Case Number: C15-2020-0020

Public Hearing: Board of Adjustment, May 11th, 2020

RE: 1401 E 3rd Street Setback Variance Request
CASE # C15-2020-0020

Public Comment Re: Case Number C15-2020-0020 (1401 East 3rd St.)

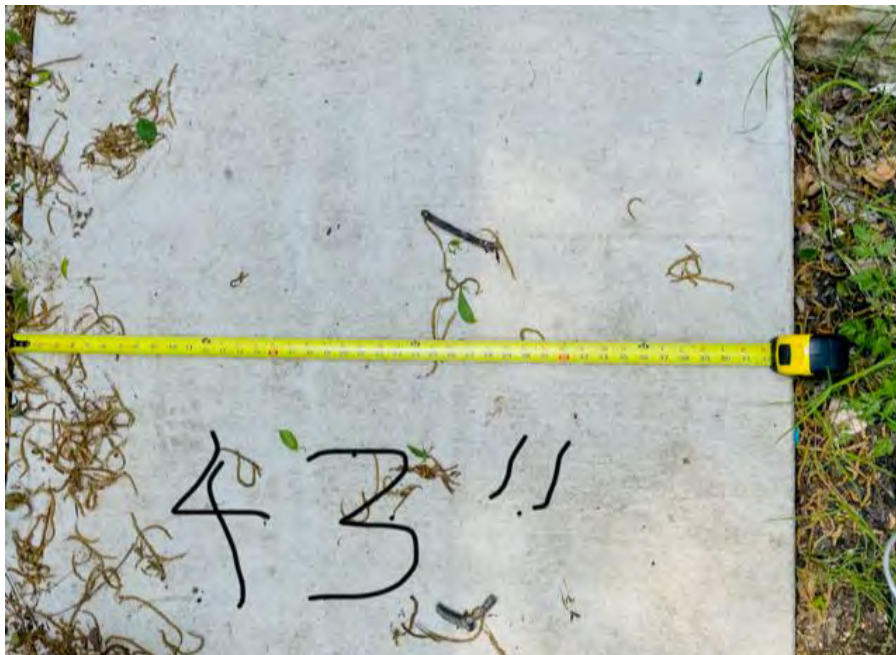
As you consider this variance request, please keep these measurements in mind:

- **82 inches.** At the northeast corner of the structure, the as-built clearance between 1401 E 3rd Street and the abutting historic structure at 1403 E 3rd Street is 82” (6’-10”). The City’s official side-lot setbacks call for 10’ of clearance; the as-built clearance is 68% of what is required.

- **43 inches.** As currently built, the width of the first-floor entrance sidewalk is 43”. Since the fence between properties is not on the lot line, this clearance is not guaranteed going forward.

- **18 inches.** The approximate distance that the exiting fence built by Durham Trading Partners encroaches on the abutting property at 1403 E 3rd Street is 18”. Note that the existing sidewalk straddles over the lot line by approximately 10”.

- **33 inches.** If the abutting property owner ever moves the fence to the lot line, the width of the first-floor entrance sidewalk will be reduced to a non-ADA-compliant width of 33”.

The City’s development guidelines do not allow for this type of error. **Per the City’s published Residential Inspections flowchart, all pre-foundation development activities are predicated upon the completion a third-party form survey.** As a homeowner, I was able to negotiate City’s residential development process successfully. It is more than reasonable to expect a professional developer to do so.

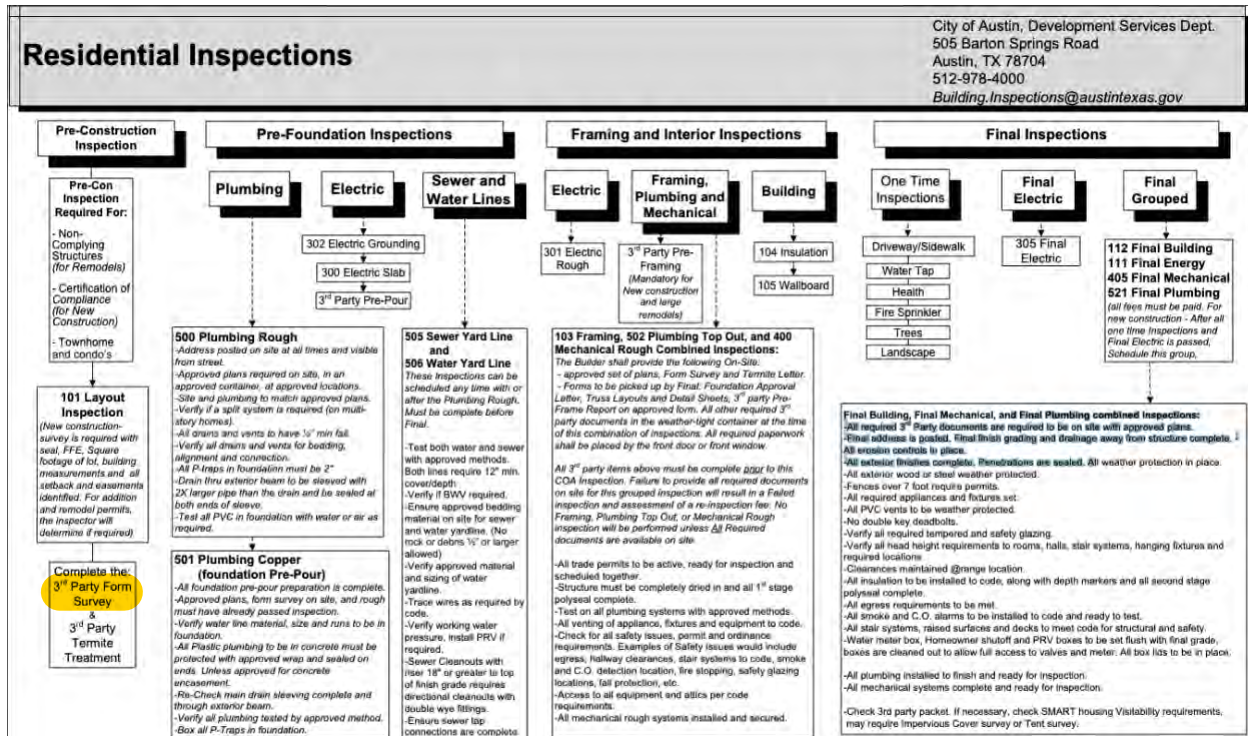
In practice, the as-built clearance is already quite tight and restricted. If the abutting property owner ever moves the fence to the property line—as is common during redevelopment activities—the sidewalk clearance will decrease from the existing 43" to a non-ADA-compliant width of 33" (2.78 feet).

A000

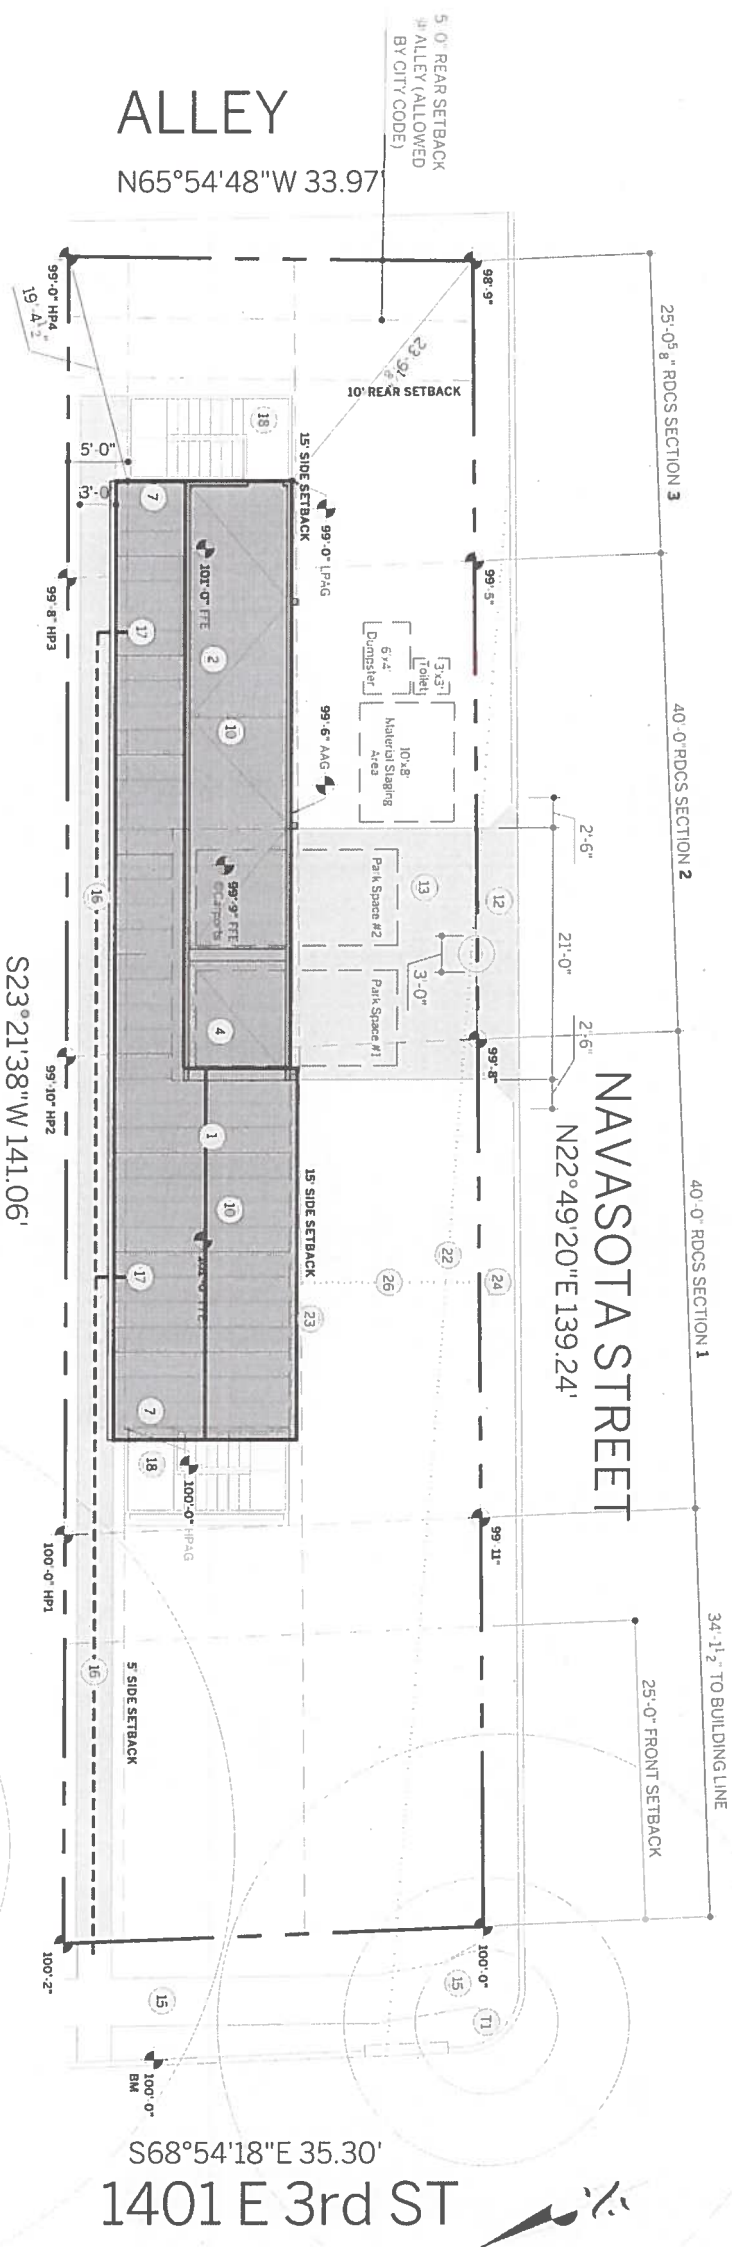
As the homeowner immediately to the south of this property, I have an immediate interest in **the Health and Safety Concerns** associated with new structure that is being built in violation of City codes designed to prevent the spread of house fires. As a resident, I first alerted the City to my concerns about this set back violation on January 20th, 2018, in a letter to my planning commission district representative, Jeff Thompson. At that point the foundation for the property had been staked out, but not poured. I sent Jeff a pictured of the clear violation of the minimum 5 foot setback and he in turn pulled the site plan and contacted City staff.

The site plan (attached) confirmed that the plan was approved in violation of the code, but no immediate justification was apparent. Once the foundation was poured in violation of the code, I sent another inquiry. The response by City staff to this inquiry was dismissive, despite the clear violation and

| SHEET TYPE Elevations, Bldg 1. | | A201 | |

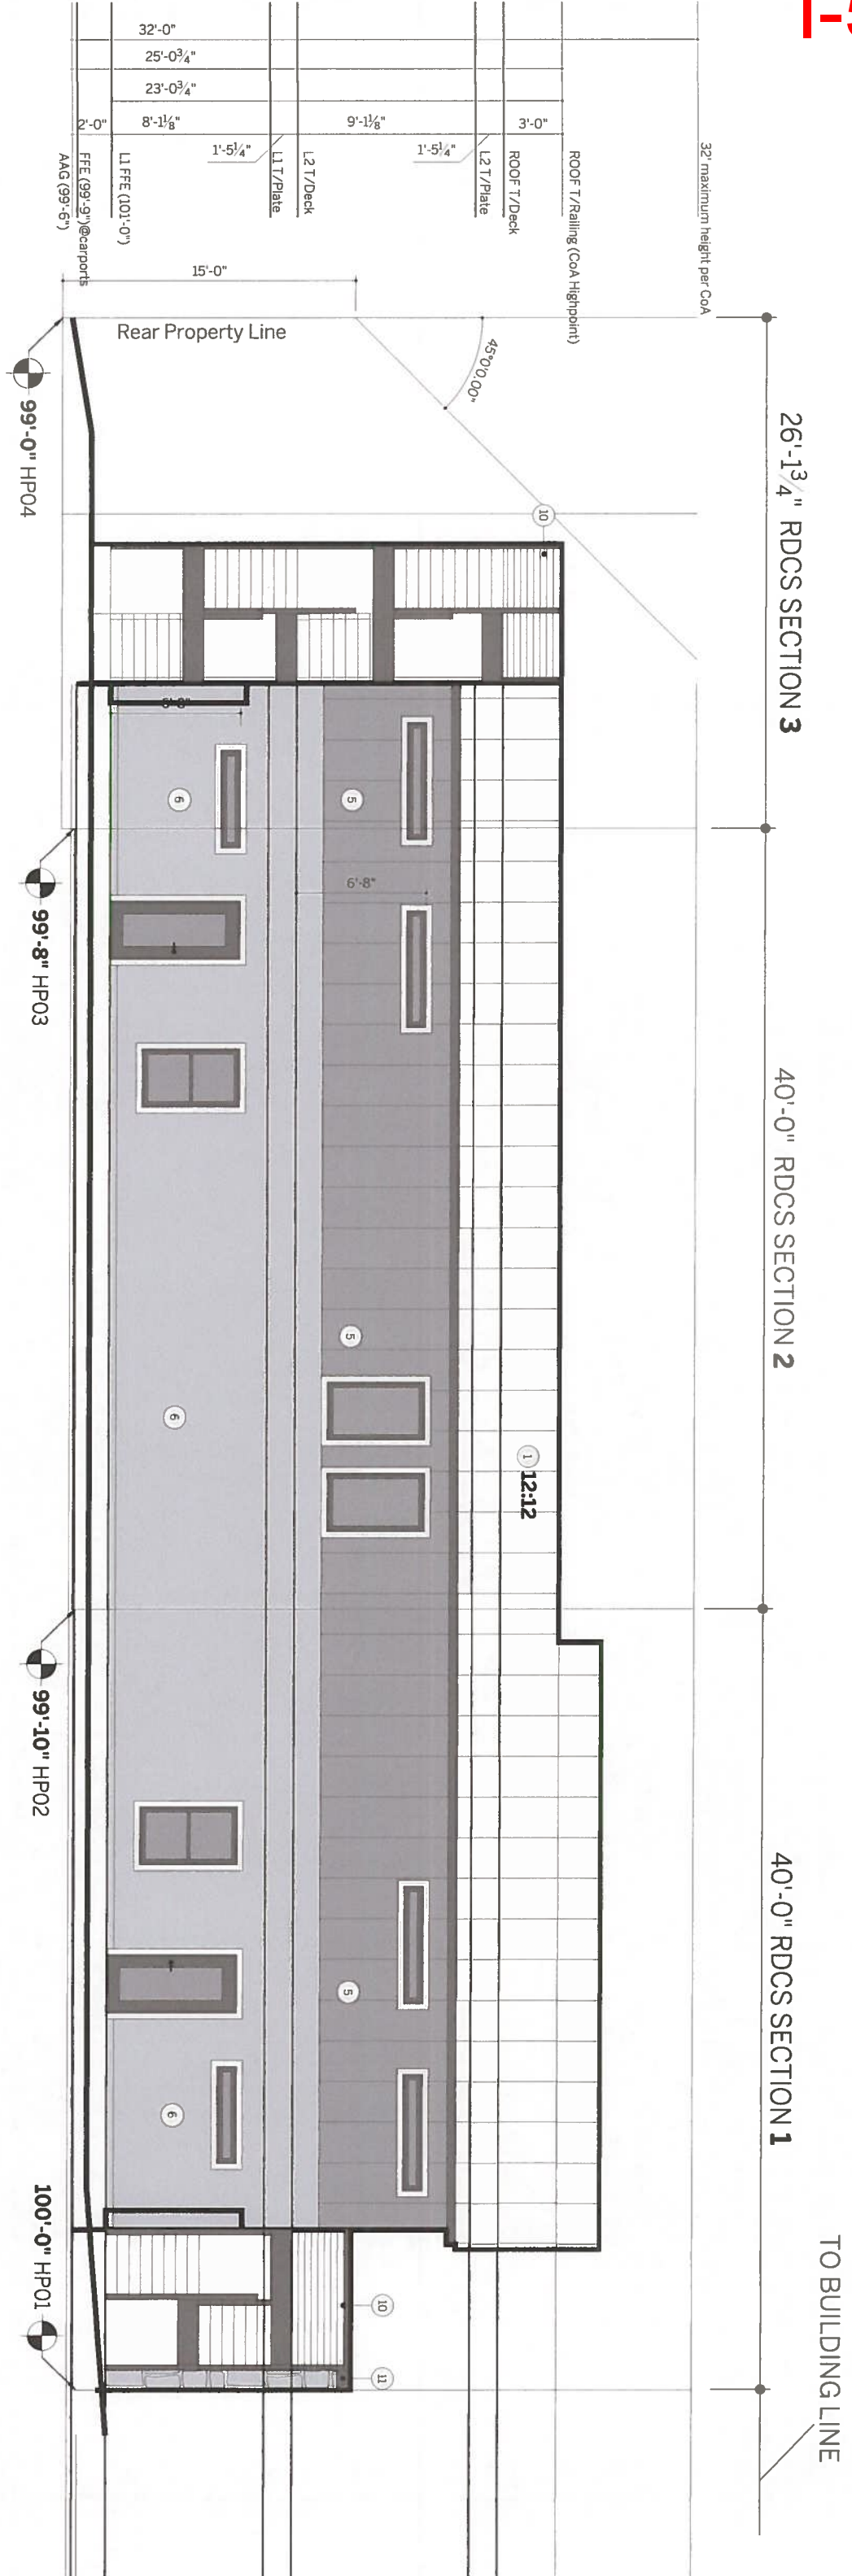
I'm looking into a case on behalf of a district 3 constituent. She is concerned that the house being built at 1401 E 3rd does not have a 5 foot side setback.

Looking at the plan (2017-043148 PR), it clearly shows that the house encroaches on the 5 foot set back line. Can you tell me if this is in fact an approved plan and if so can you please explain why?

This is an approved plan and there is a projection into the 5 foot setback. This is a common concern, but the code does allow for eaves and other incidentals to project 2 ft. into any setback, LDC 25-2-513 B. If you look at sheet A201, you can see the elevation view of the proposed residence. On this elevation, you can see the footprint of the building stops at the 5 ft. setback and the eaves project into the setback. Again this is an allowed and common design.
